Re: Variance Pre-Filing Letter of Explanation, Dr. Robert Beer Residence, 1313 St. Josephs Court, Crownsville, MD 21032 (Permit No: B02422311 – review comments attached)

BEER RESIDENCE APRIL 2024
1313 ST. JOSEPHS CT. CROWNSVILLE 21032

CONFIRMATION OF PRE-FILE

PRE-FILE #: 2024-0007-P(revised)
DATE: 1/23/2024
OPZ STAFF: Jennifer Lechner
Kelly Krinitz

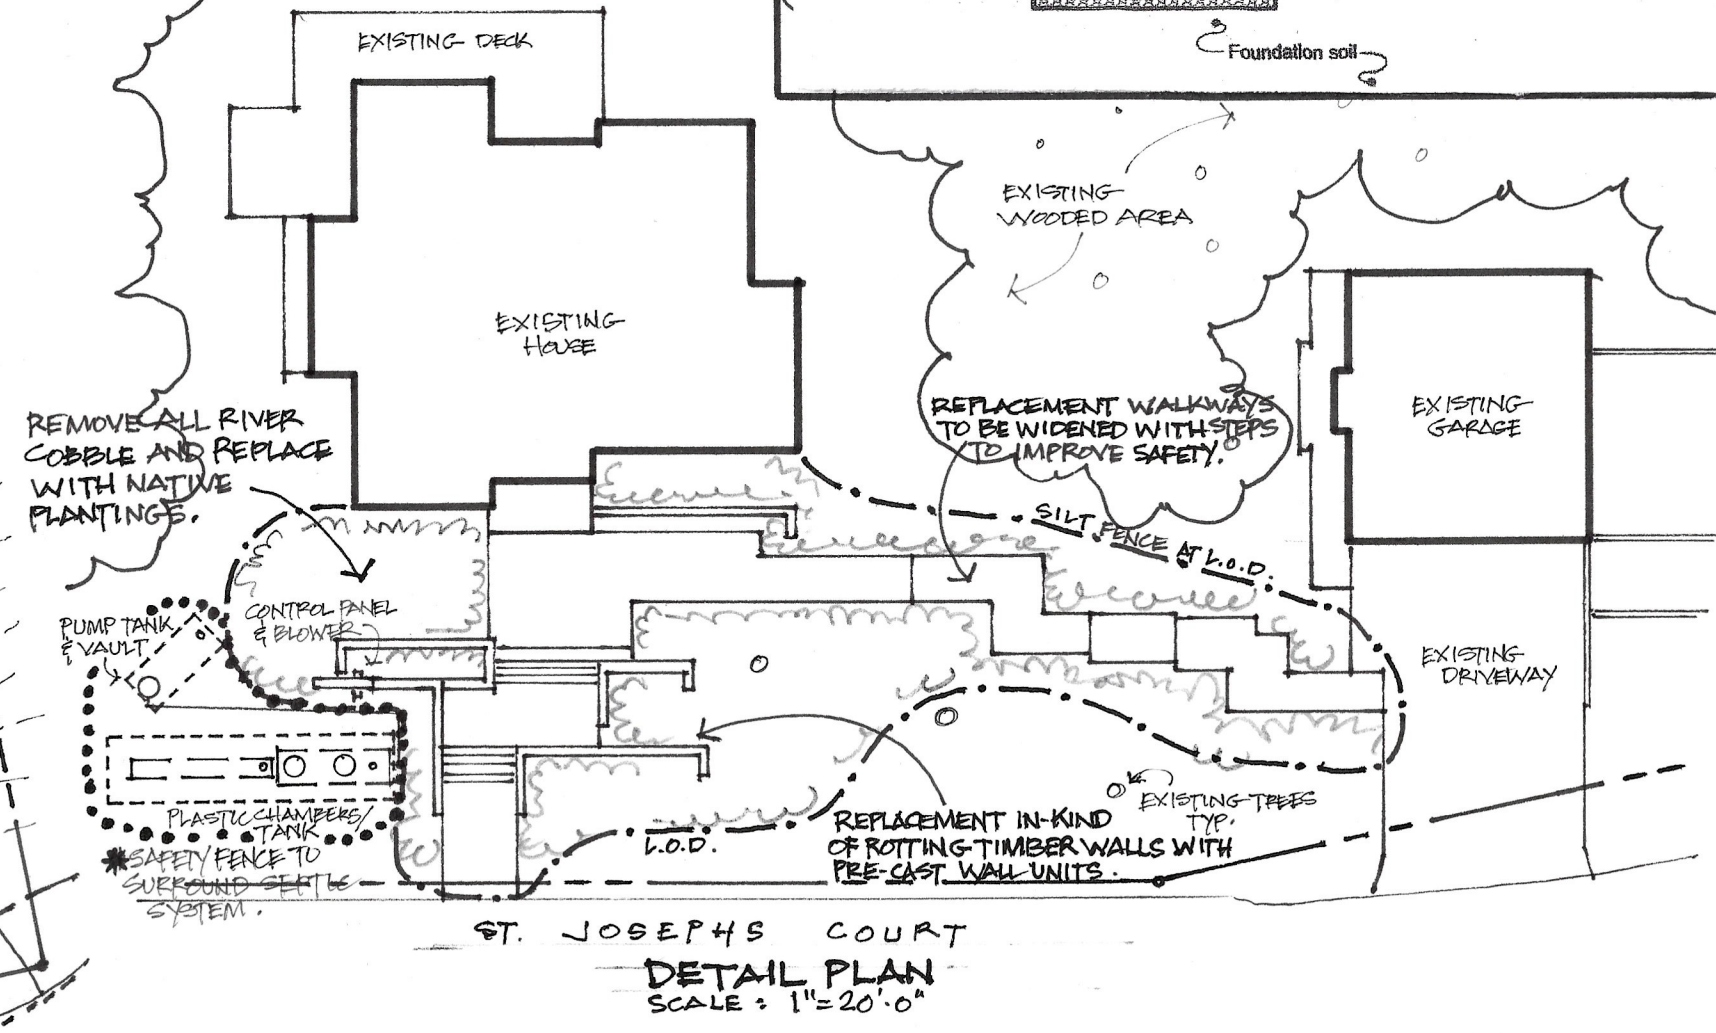
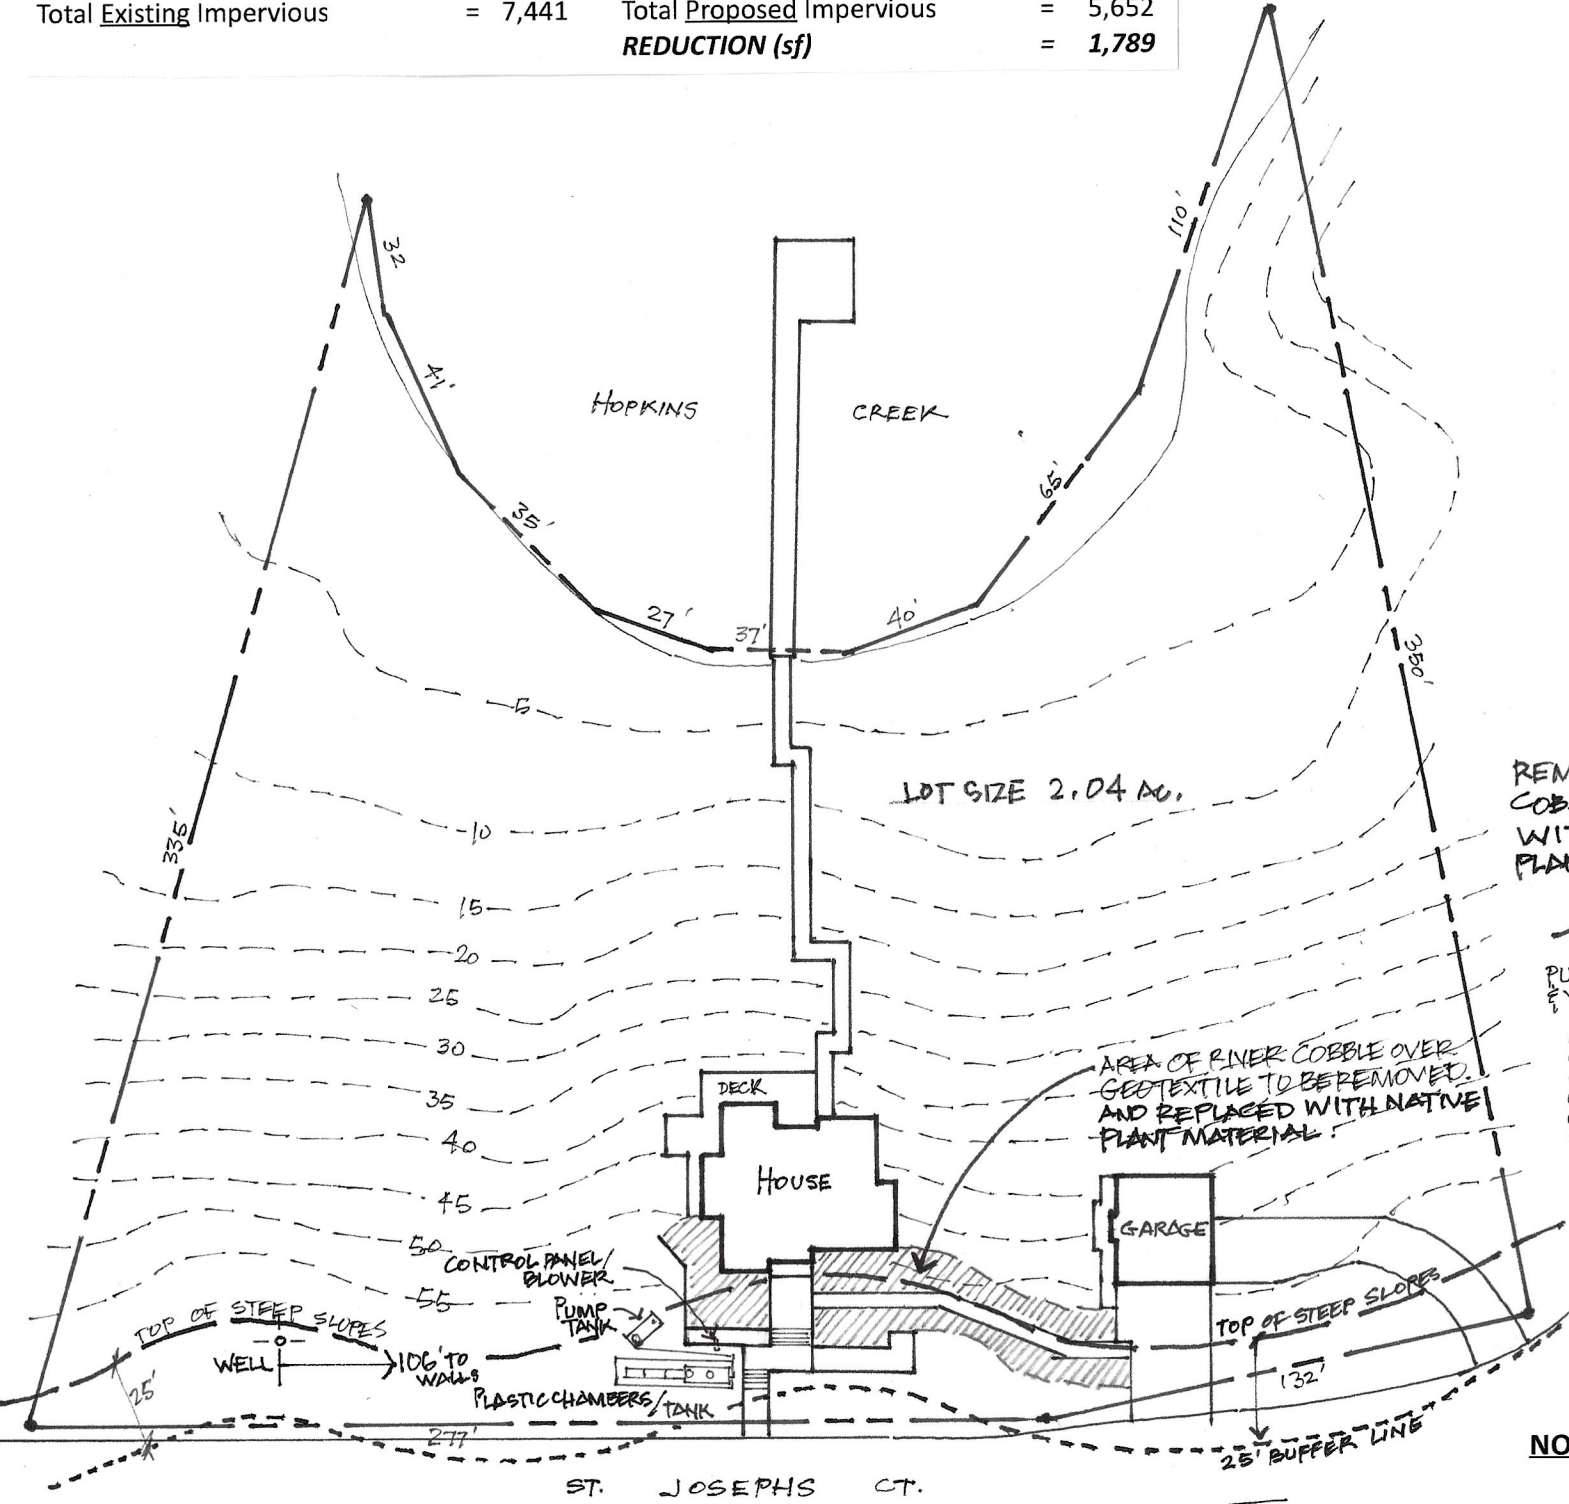
Show the entire septic system including the BAT unit, surrounding disposal bed, and existing septic tank per installation diagram T02047435 on the site plan. For a copy of health department records that may be used as reference please visit <https://www.aahhealth.org/environmental-health/wells-and-septic-systems/request-copies-septic-or-well-records-online>

Comment: Clearly show on the site plan that no excavation will take place closer than the existing retaining walls to the existing septic system on site.

The existing septic system must be fenced off prior to septic review approval of this building permit. Please contact me for a site visit once this has been completed

Show the existing well AA-81-3662 on the site plan. The proposed retaining walls must be 30' or no closer than existing to the well on site.

Comment: The existing well (AA-81-3662) must be raised to at least 8" above grade and fitted with a two-piece (Water Systems Council PAS 97) vermin-proof cap prior to Health Department approval of this permit. Two-piece caps held to the casing with horizontal bolts/screws are not permitted. Once the work has been completed, please submit pictures of the wellhead to hdohts00@aaacounty.org to show compliance so that the well review may be approved

The expanded buffer should be indicated on the site plan.

There is a discrepancy between the overall site plan (showing the whole property) and the detail (project enlargement). The enlargement appears to indicate an increase to the lot coverage for the replacement of the existing walkway from the garage (what is shown with 3 steps noted). Therefore, this does not appear to be an in kind replacement of the walls and walkways. The Letter and plans should not refer to this as a replacement in kind.

Detail-enlargements for both the existing and the proposed improvements are recommended for clarification. Any lot coverage to be removed should also be shown on the existing site plan, and noted in the Critical Area Notification Form and the Narrative, for verification.
